## Product Change Notice

Issue Date: 22-November-2021

Introduce new lead frame source and die source

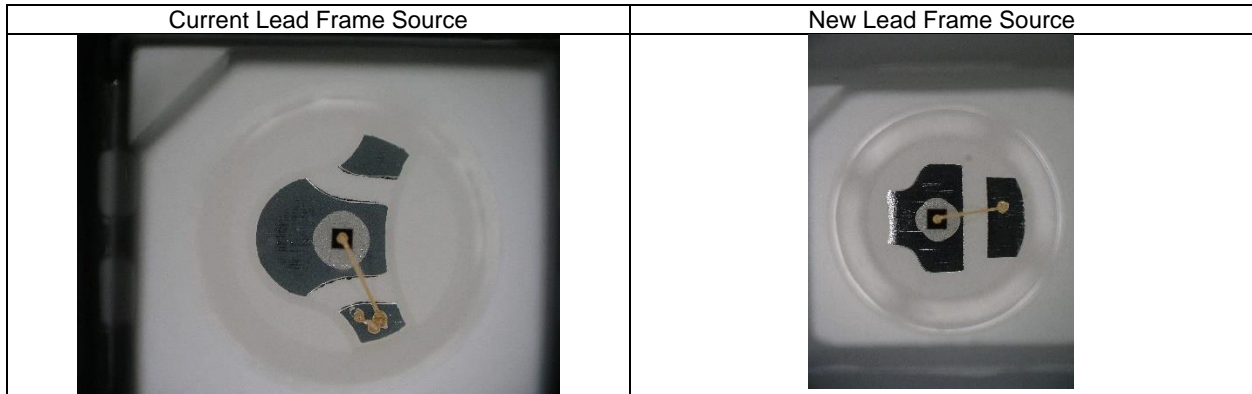
1. Lead frame change (Part numbers in Group 1 and 2)

Outlook is different as illustrated below:

Forward current vs forward voltage

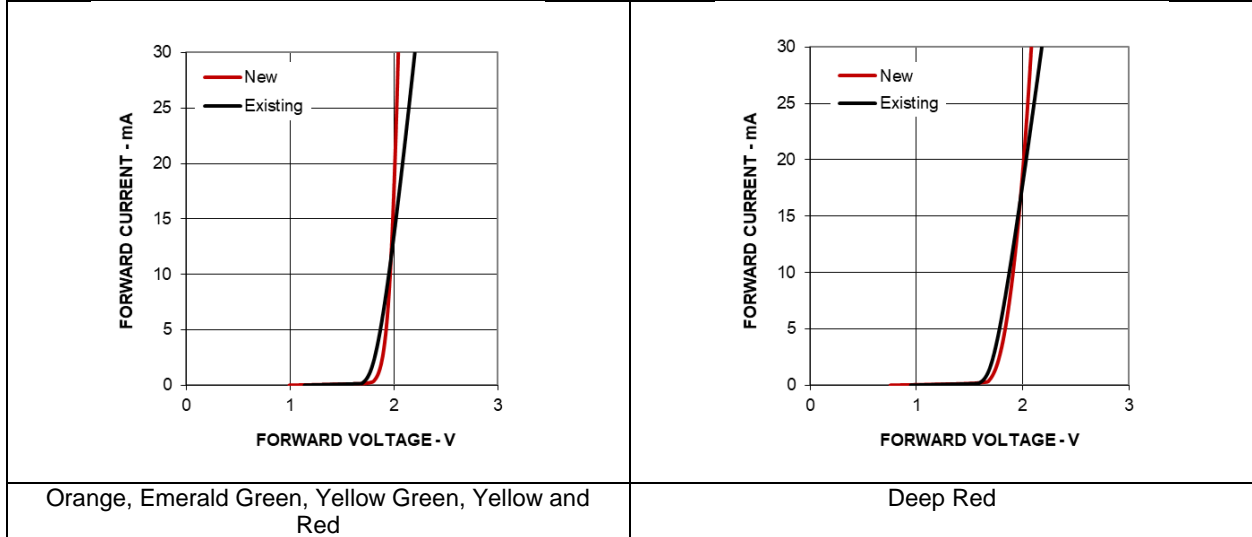
2. New die source (Part numbers in Group 2 and 3)  
 Following are the changes in product characteristic

Relative intensity vs wavelength

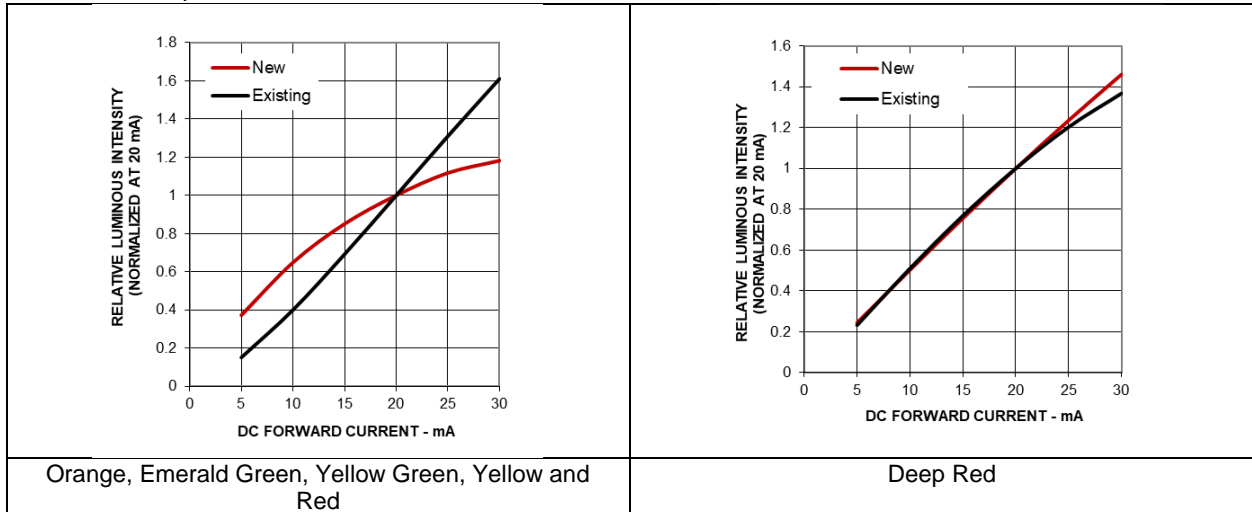
Relative intensity vs forward current

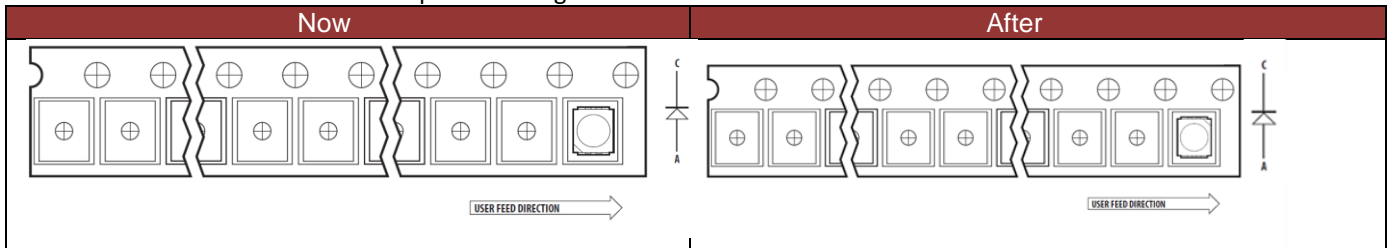
3. Orientation for HxMH-A100 in Group 2 will change as illustrated below:

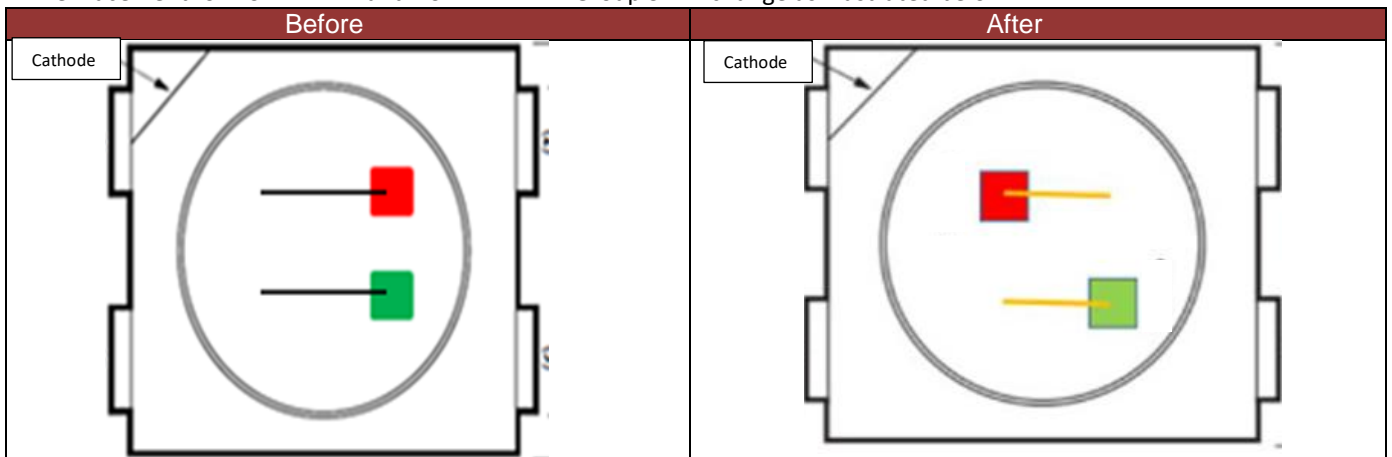
4. Die Placement for HSMF-A211 and HSMF-A212 in Group 3 will change as illustrated below:

Parts identification:

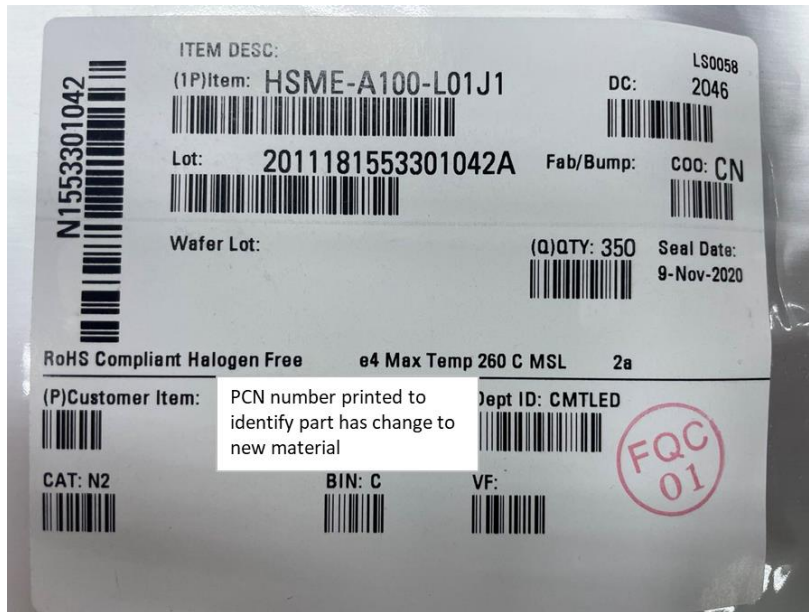
PCN number identification will be printed on the mother label to identify the lot has changed to new material as indicated below.
